MAYFLOWER PLATINUM

Details of Additions & Alterations

Flat No	605	Block no.	'B'
Flat Area	1800 sft	Type	Deluxe / Luxury
Buyer Name	Vavilala Raghavendra kumar		
Phone No.	7738721394/9666931394	Email	swetha@gmail.com

Description	Direction	Owners & Developers :	Date :	18.03.2020	Promoted by
WORKING DRAWING OF FLAT.NO.B-5		Modi Properties Pvt Ltd.	Prepared By :		Modi Properties Pvt. Ltd
		Project Name & Phase :	Approved By :	Soham Modi	Phone:+91-40-66335551
		MANELOWR PLATINUM	Scale :	N.T.S

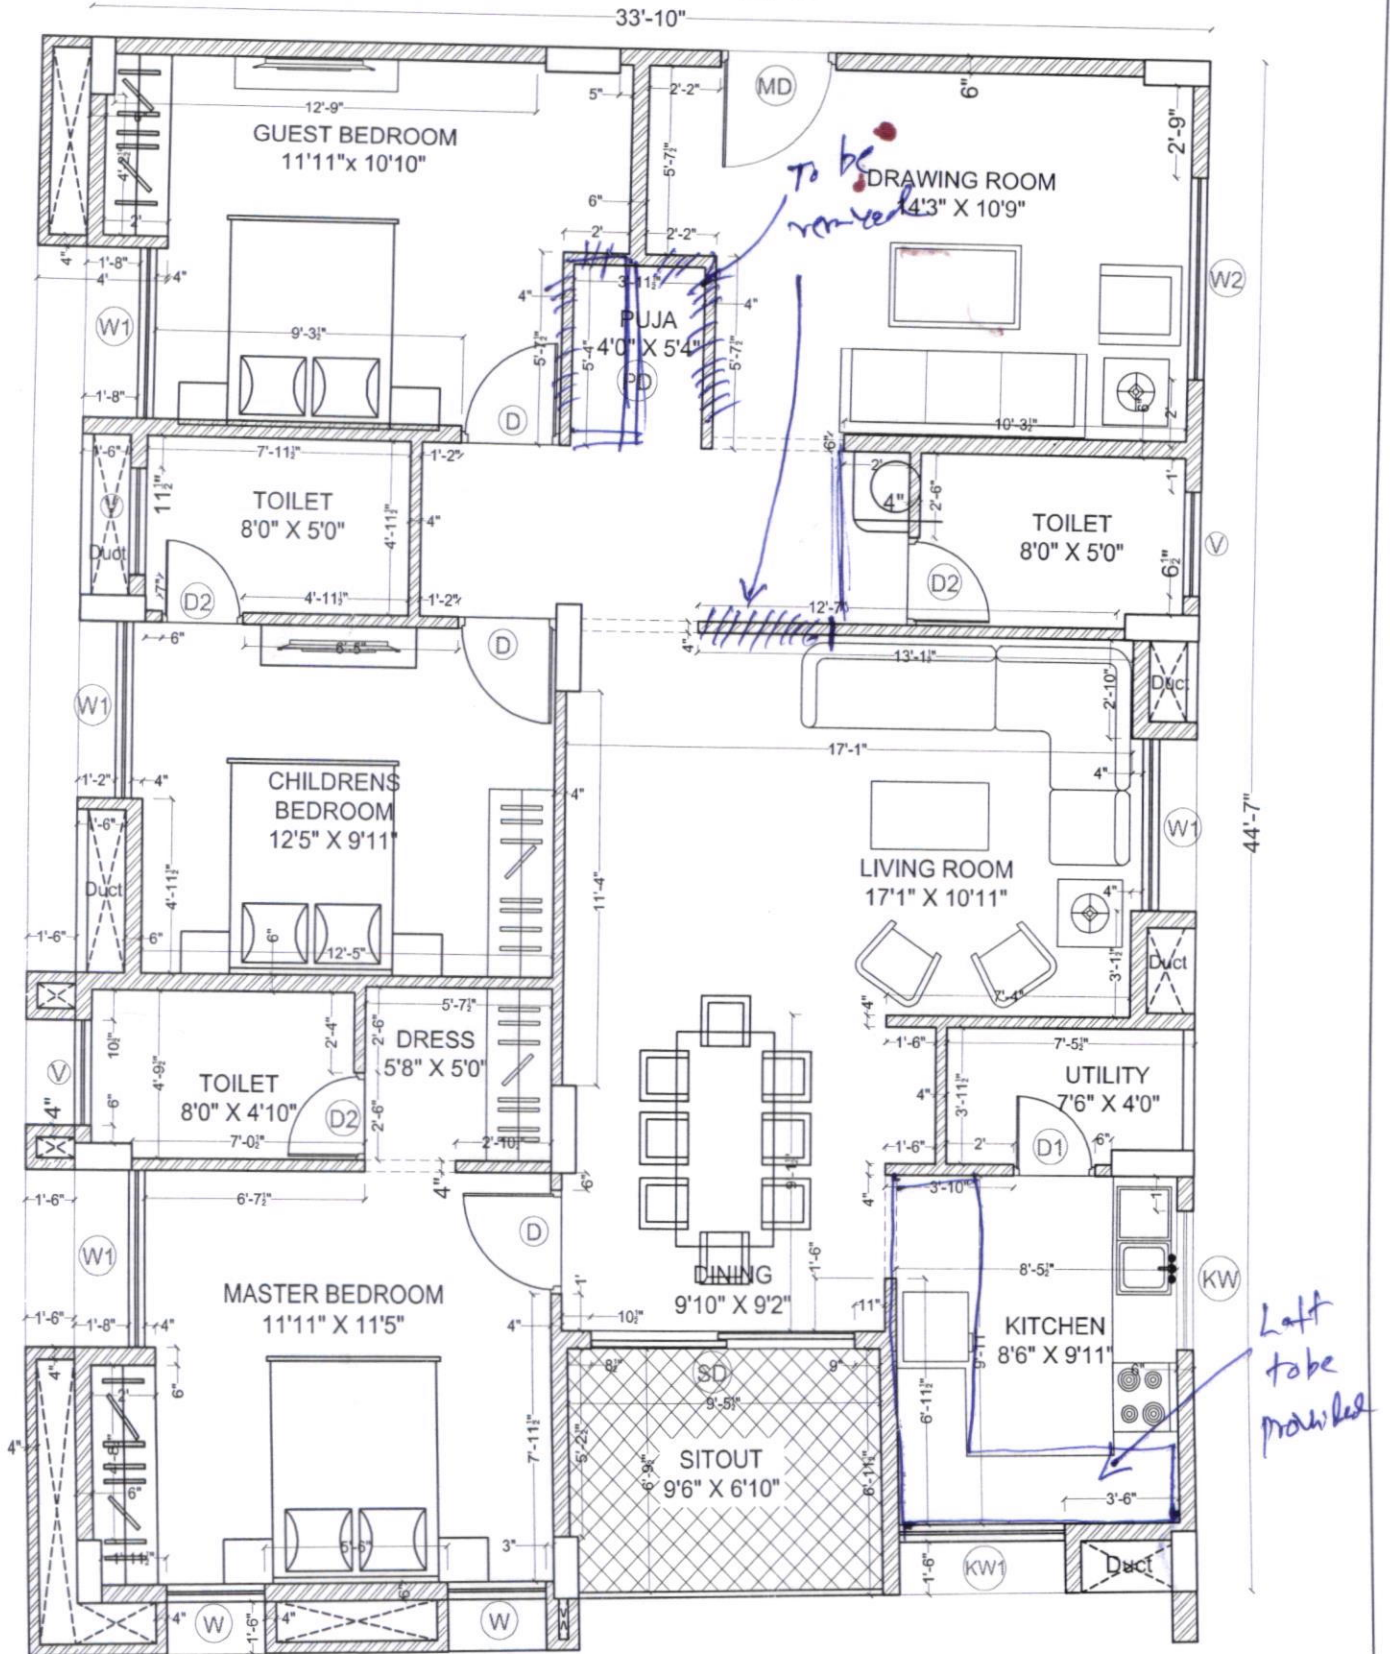
- ① * Common Bathroom door frame should be 3ft. with threshold.
- ② * Extend left South side wall to ~~west~~ east wall marked on plan.
3. Extra top required is balcony.
4. * Kitchen extra top point in line.

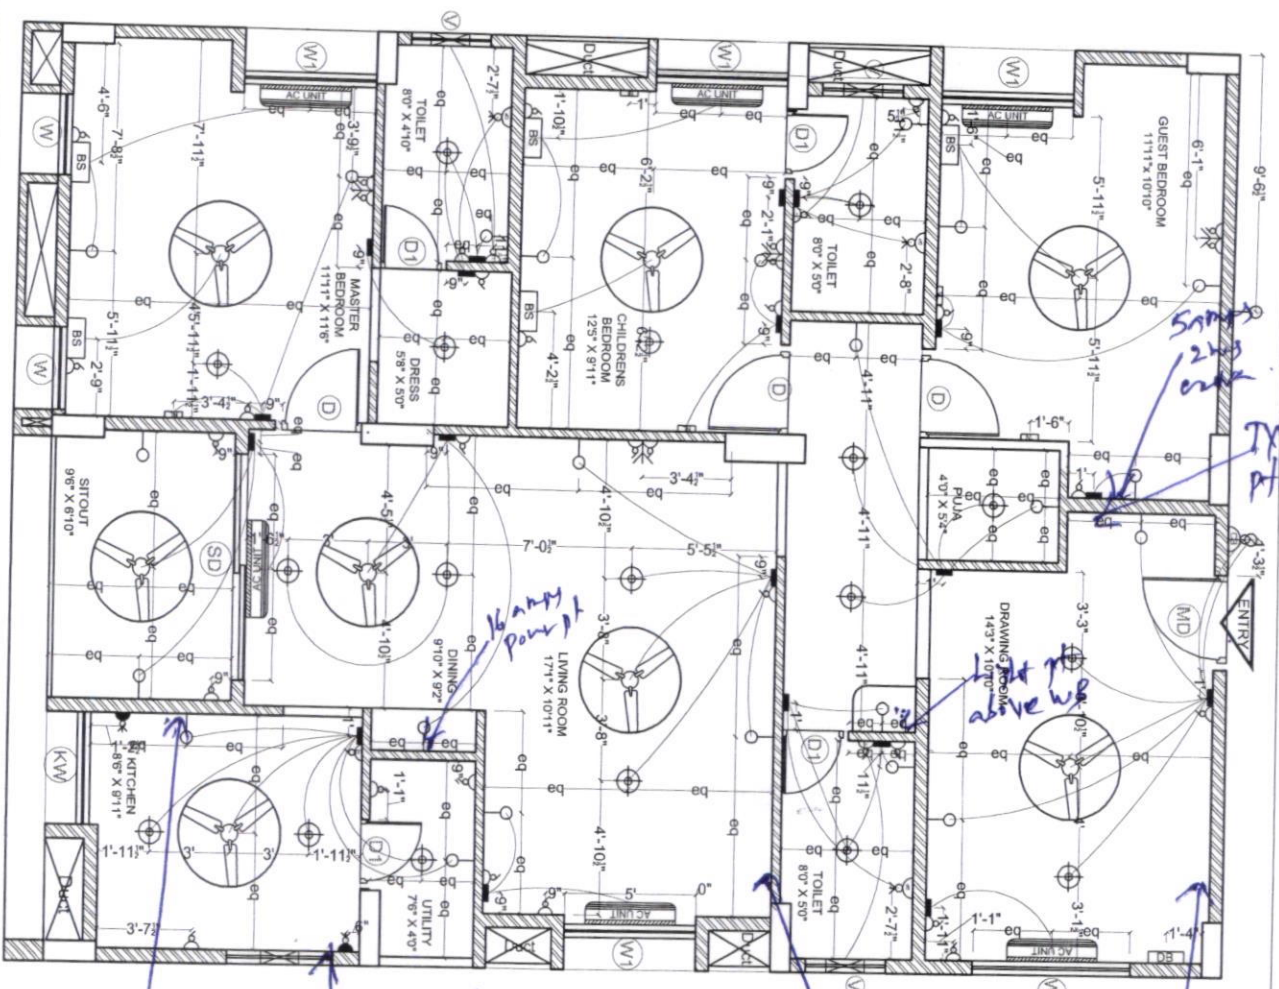
- ① Extra powerplug above sink
- ② Extra powerplug near fridge & one more power ~~normal~~ plug
- ③ Dining & utility area one powerplug
- ④ * Extra ~~plc~~ two plugpoint in Drawing room at N.E corner.
- ⑤ * Internet wiring in all rooms Imp
- ⑥ * N.E corner in drawing room (Puja room)
- ⑦ Light pt above new wash basin. (6'0" ht)
- ⑧ TV cable in all rooms

- ① utility top height increase - (3'0" ht)
- ② tiles - ~~10ft~~ (7'0" ht)
- ③ extra inlet, outlet in utility area
- ④ two taps with 3ft height
- ⑤ shift W.B from dining area to common bathroom point.
- ⑥ * In M.B.R shift EWC to north wall marked to plan according to common bathroom.
- ⑦ * W.B should be wall mounted in all bathroom with pedestal
- ⑧ * Change W.B to north wall in M.B.R
* A.B (marked on plan)

ELECTRICAL PLAN OF FLAT-B5

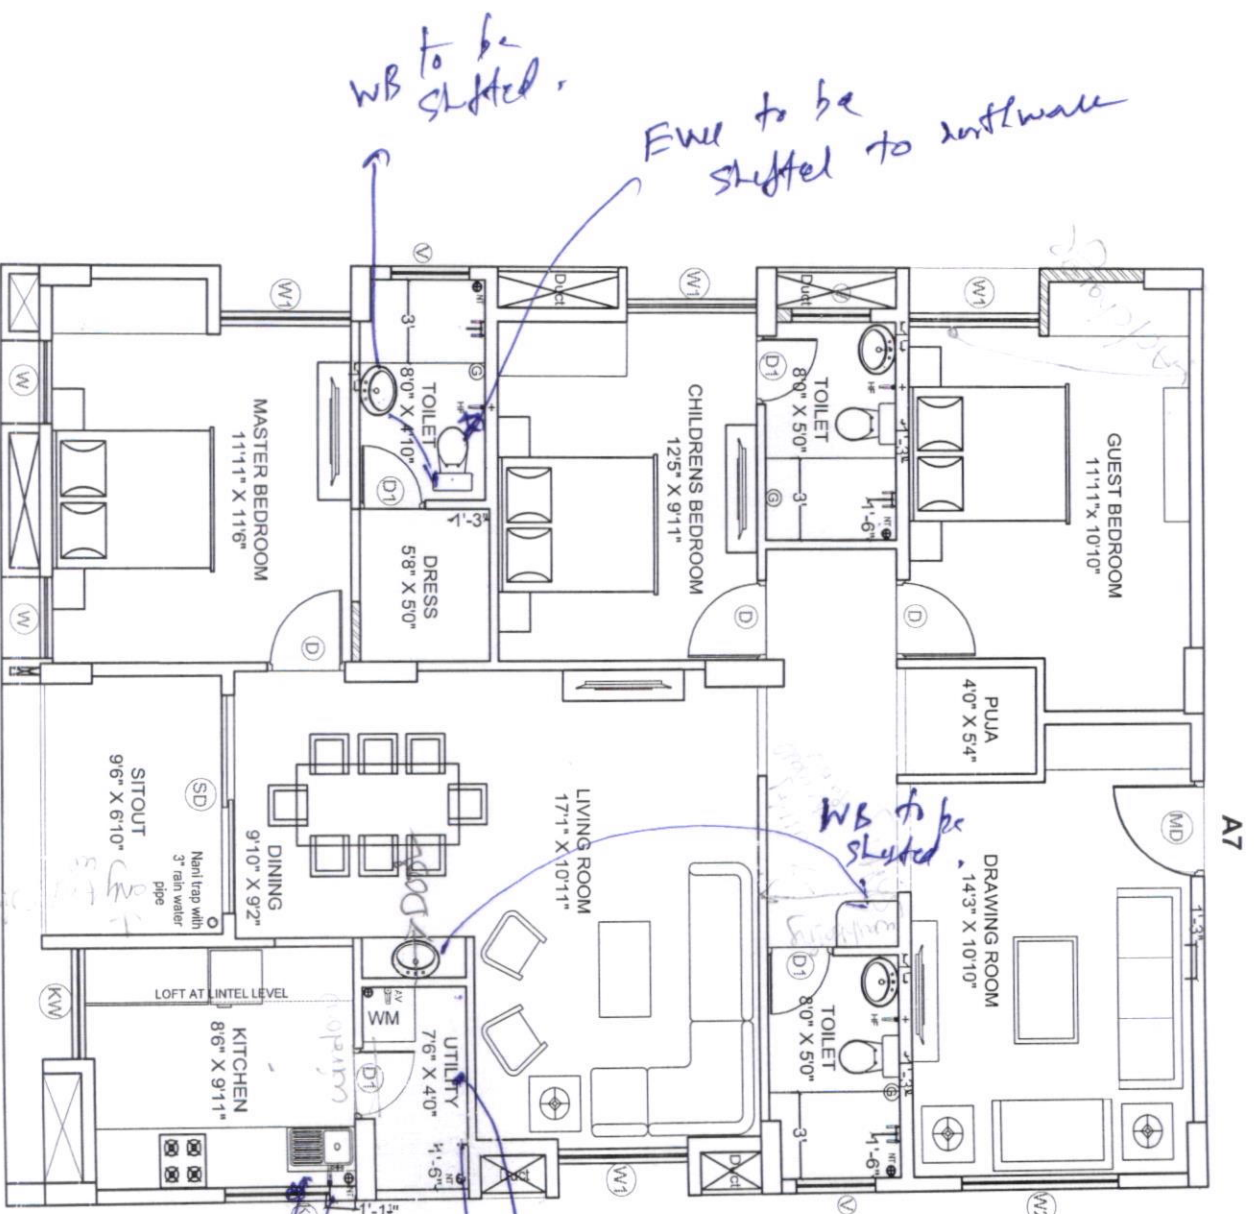
one 16amp & one 5amp power pt. each

Each power plug 16amp.

Two 5amp plug pt. for 2nd floor (P.O.J.)

Two 5amp power pt.
